## Product Change Notice (PCN)

PCN Number: **PCN-0451149R-01**

Product(s) Affected: PJ-037B

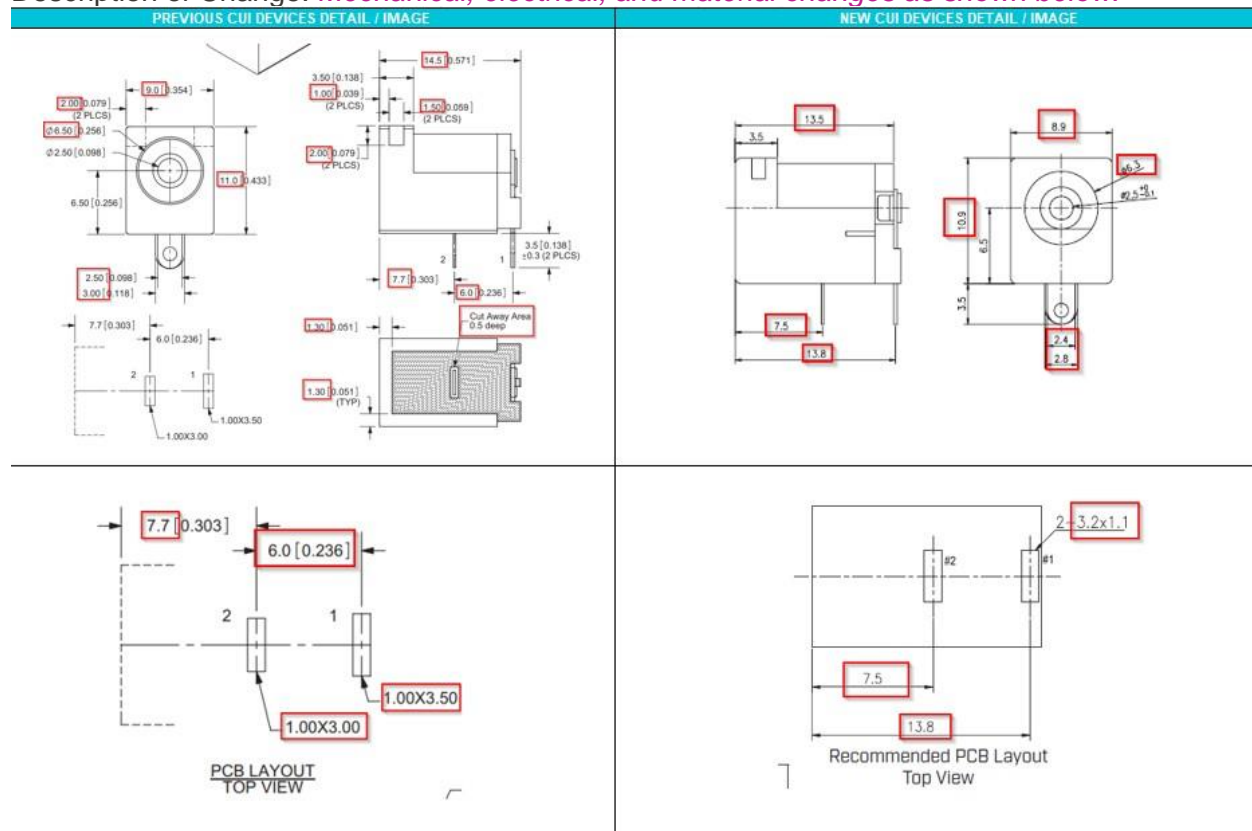
Description of Change: *Mechanical, electrical, and material changes as shown below:*

MATING PLUG  
Jack Insertion Depth: **9.0 mm**

MATERIAL	PLATING
center pin	<b>copper</b>	nickel
terminal 1	brass	<b>tin</b>
terminal 2	<b>copper alloy</b>	<b>tin</b>
plastic	PBT

Insertion/Extraction force adjusted to 0.3 ~ 2.0Kg

MATING PLUG  
Jack Insertion Depth: **9.8 mm**

DESCRIPTION	MATERIAL	PLATING/COLOR
center pin	<b>copper alloy</b>	nickel
terminal 1	brass t=0.3 mm	<b>nickel-silver</b>
terminal 2	<b>phosphor bronze t=0.3 mm</b>	<b>nickel-silver</b>
housing	PBT (UL94V-0)	black
cover	PBT (UL94V-0)	black
